SUBJECT: **CONDITIONAL USE / CLASS 3 SITE PLAN REVIEW CASE NO. CU-
SPR20-09**
2960, 3000 and 3010 LANSING AVENUE NE - 97301
AMANDA NOS. 20-118295-ZO & 20-118296-RP

Summary: A conditional use and site plan review to allow expansion of an existing religious assembly.

Request: Conditional Use and Class 3 Site Plan Review for construction of a new 7,561 square foot fellowship building for an existing religious assembly, on a 3.8-acre property located at 2960, 3000, and 3010 Lansing Avenue NE – 97301 (Marion County Assessor Map and Tax Lot numbers: 073W13AC / 5600, 5700, and 5800).

- Attachments: A. Vicinity Map
B. Site Plan
C. Applicant's Statement
D. Public Works Memorandum

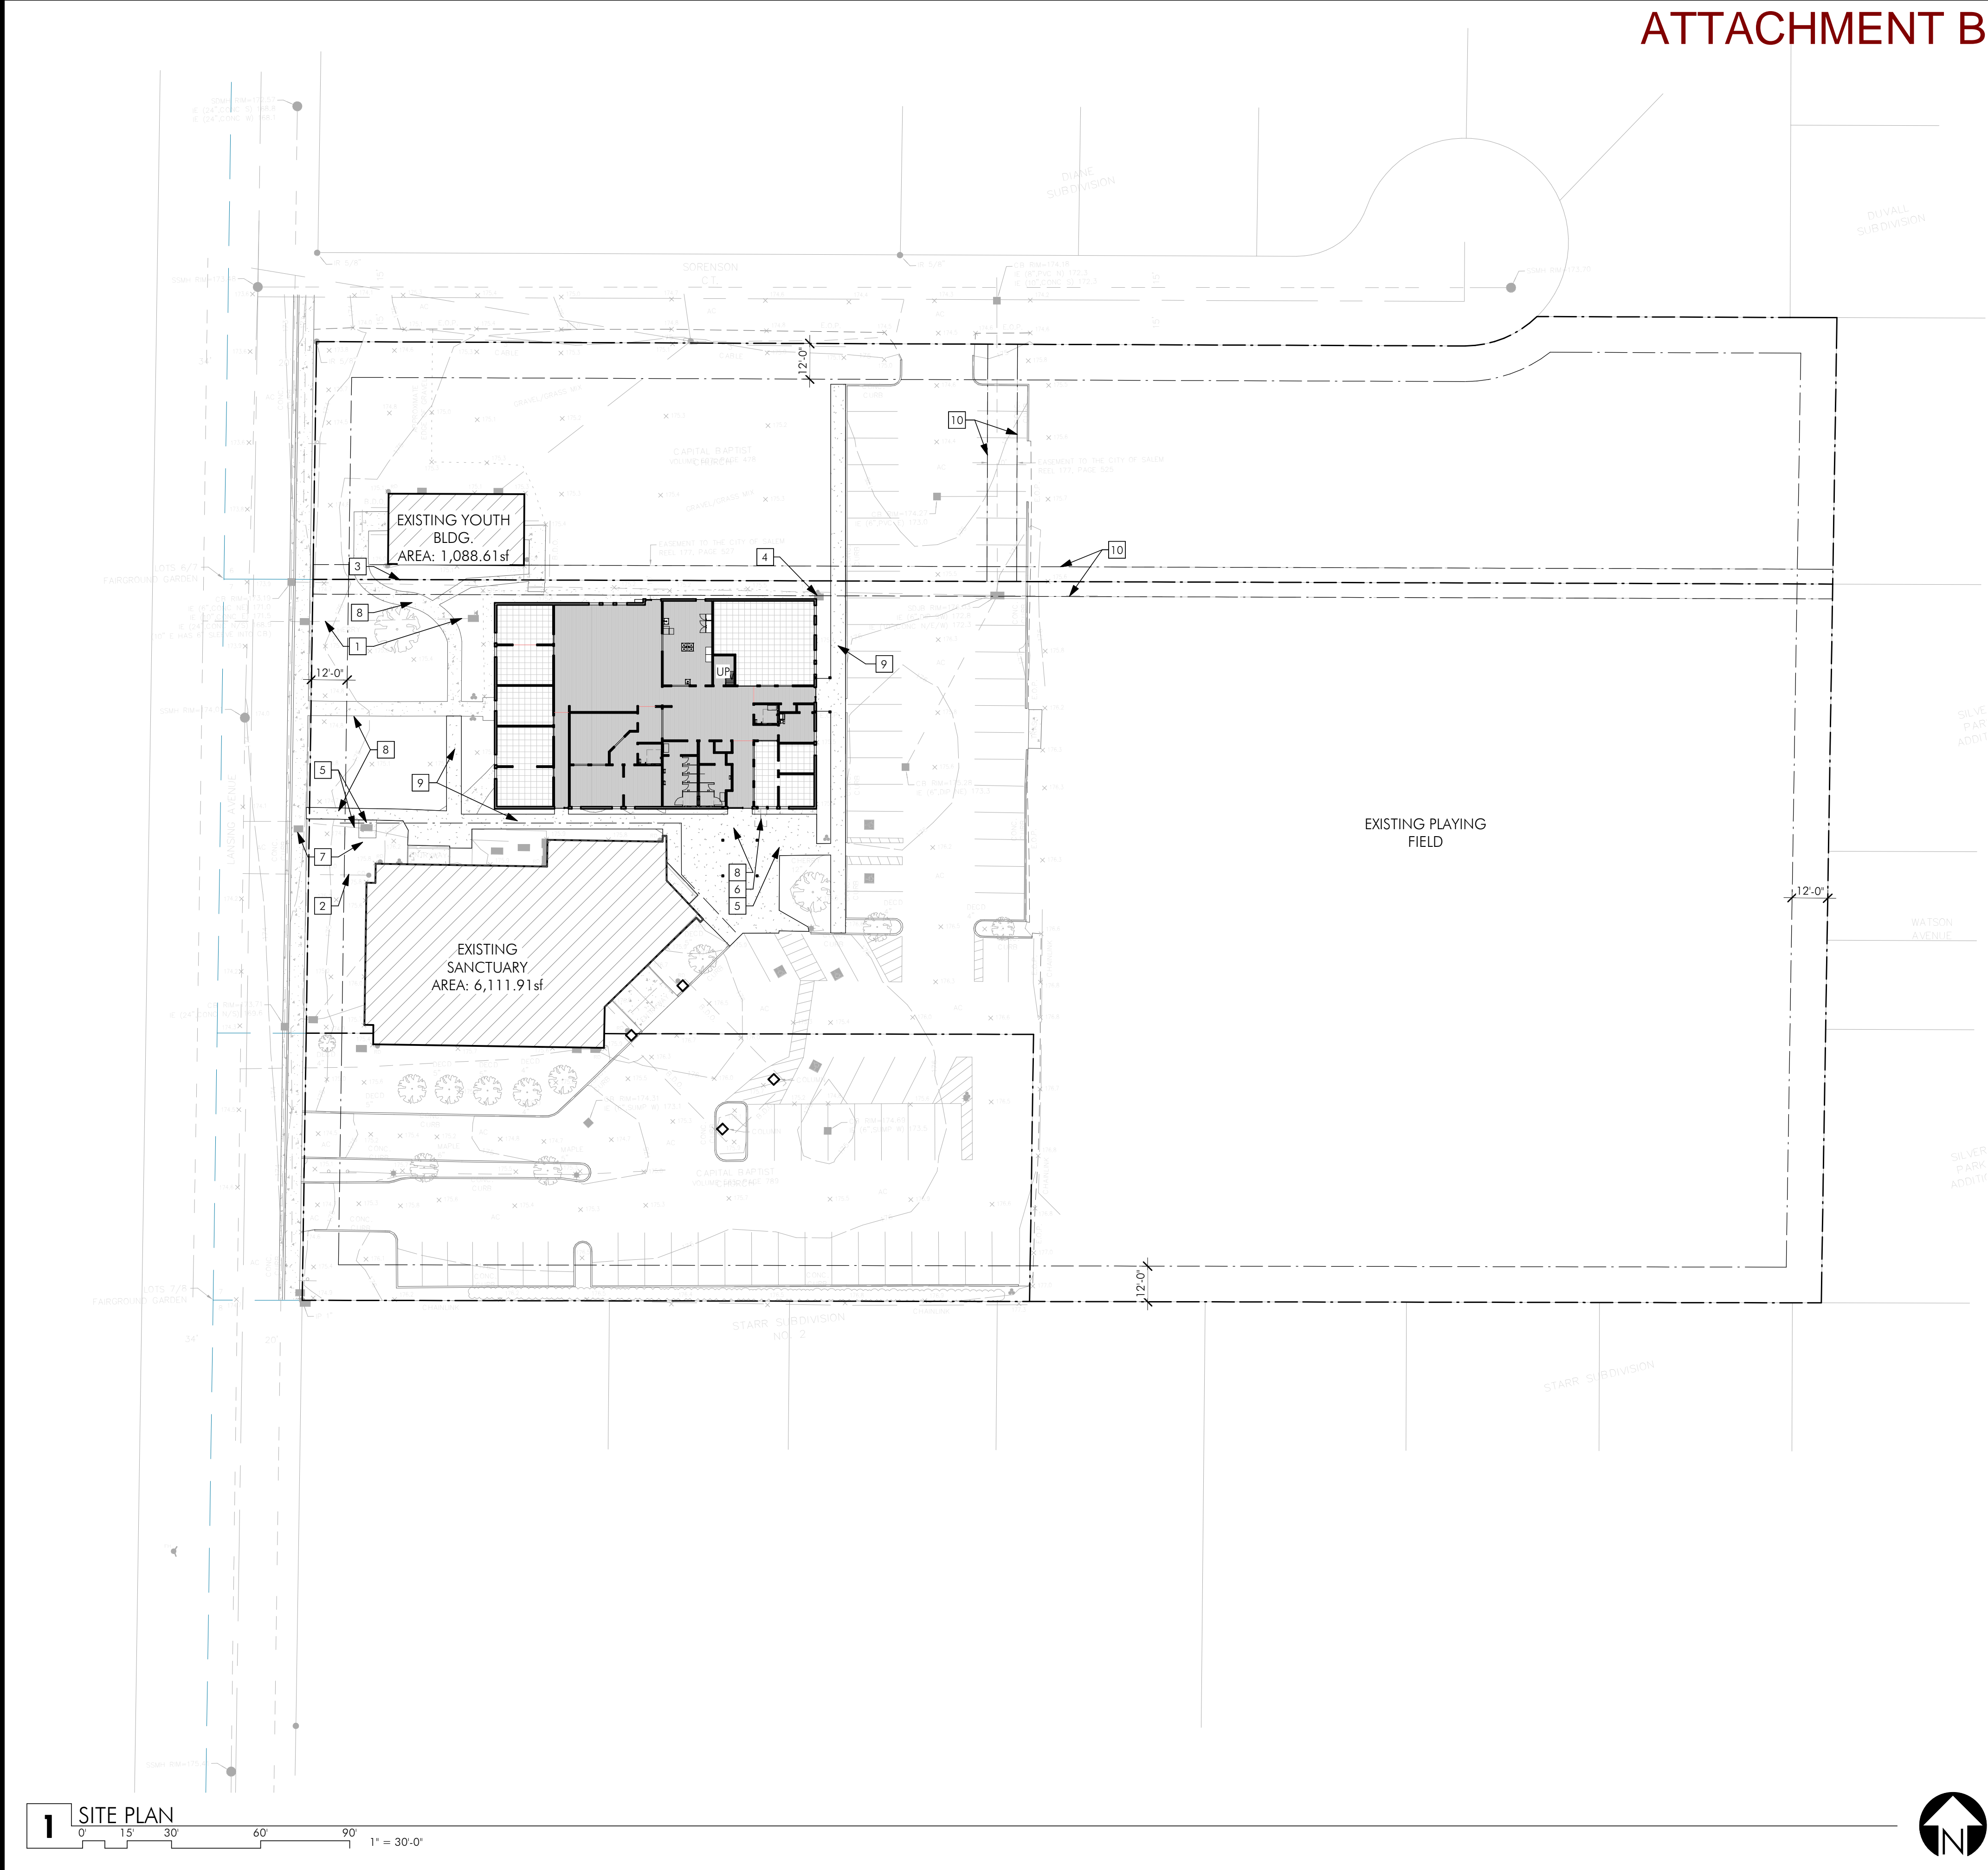
The special use standards require all lot area not developed for buildings, structures, parking, loading, or driveways to be landscaped as provided in SRC Chapter 807 with Type A Landscaping. Type A landscaping requires a minimum of 1 plant unit per 20 square feet of landscaped area. No existing landscaping is proposed to be removed and the applicant's site plan does not indicate any new landscaping.

Based on site visits and aerial photos, there are concerns that off-street parking occurs within an existing landscaped area on the northwestern corner of tax lot 5600. To ensure that the proposal minimizes the impacts on the neighboring property now and in the future, staff recommends the following condition of approval:

North and West – abutting street: The proposed building is not more than 25 feet in height and is more than 12 feet from all three streets, meeting the standard. The existing vehicle use area does not meet the minimum 15-foot setback requirement adjacent to existing interior property lines.

North, South and East– abutting RS zone: The proposed building is not more than 25 feet in height and is more than 15 feet from the south, west and east property lines. An existing interior property line abuts the new fellowship building to the north with a proposed setback of 6-feet 5-inches. The existing vehicle use area does not meet the minimum 15-foot setback requirement adjacent to existing interior property lines.

Staff Response: Within the 30,000-square-foot parking area, the site plan indicates approximately 1,580 square feet of interior parking lot landscaping, or 5.3 percent of the parking area, however, not all of the landscaping is planted in accordance with SRC 806. In 2001, the existing parking lot received building permit approval for expansion and improvements. Under this permit, canopy trees were required to be planted in the two planter bays at the north entrance of the parking lot. The proposed site plan indicates no landscaping within these two bays. Building permit approval required all areas in residential districts used for parking, loading, or storage of motor vehicles to be screened from all public areas and public right-of-ways by a minimum six foot high sight-obscuring fence, wall, or hedge. The existing parking lot does not have the required screening. As recommended above earlier in this report, the proposal would meet the screening requirements. To ensure that the proposal meets the interior landscaping requirements approved by a previous building permit and SRC 806, staff recommends the following condition of approval:

- Condition 1:** The proposed development shall be in substantial conformance with the approved site plan (Attachment B).
- Condition 2:** Provide a minimum 12-foot setback along the street frontages to a Type A standard in conformance with SRC 807.
- Condition 3:** Provide a minimum 12-foot setback along exterior property lines abutting residentially developed areas to a Type B standard in conformance with SRC 807. The remaining undeveloped property shall be landscaped with grass or groundcover.

- Condition 4:** On site off-street parking shall only be allowed in vehicle use areas development in conformance with SRC 806.035.

Condition 5. Prior to the issuance of a building permit, existing property lines within the development site shall be eliminated by final recording of either (1) property line adjustment(s) or, (2) a replat.

Condition 7: The two planter bays at the north entrance of the parking lot shall be planted with a minimum of one canopy tree per bay.
